CITY OF VANCOUVER

October 30, 2026

RE: 808 Broughton Street (formerly 1394 Robson Street), Vancouver, BC
Development permit application number DP-2026-00432

On behalf of the Director of Planning, your application has been approved to develop a residential development comprised of a 17-storey residential tower on a 2-storey commercial podium containing 72 units in total of which 15 are going to be turnkey social housing units with 2 levels of underground parking.

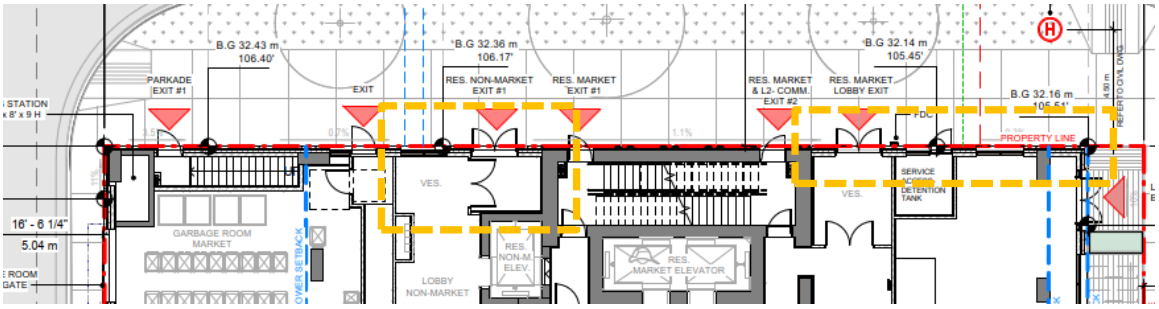
1.1 design development to improve the visual quality and create an engaging interface with the existing hotel building at 1348 Robson Street;

Note to Applicant: The proposed development provides a blank wall condition along the eastern interface. Given the relatively close building separation from the existing hotel, the applicant is to explore opportunities to provide a more visually engaging and thoughtfully designed interface for the neighbouring hotel units. This should include consideration of changes in plane, materiality, texture, pattern, architectural detailing, landscaping, or other appropriate measures to soften and enhance the interface.
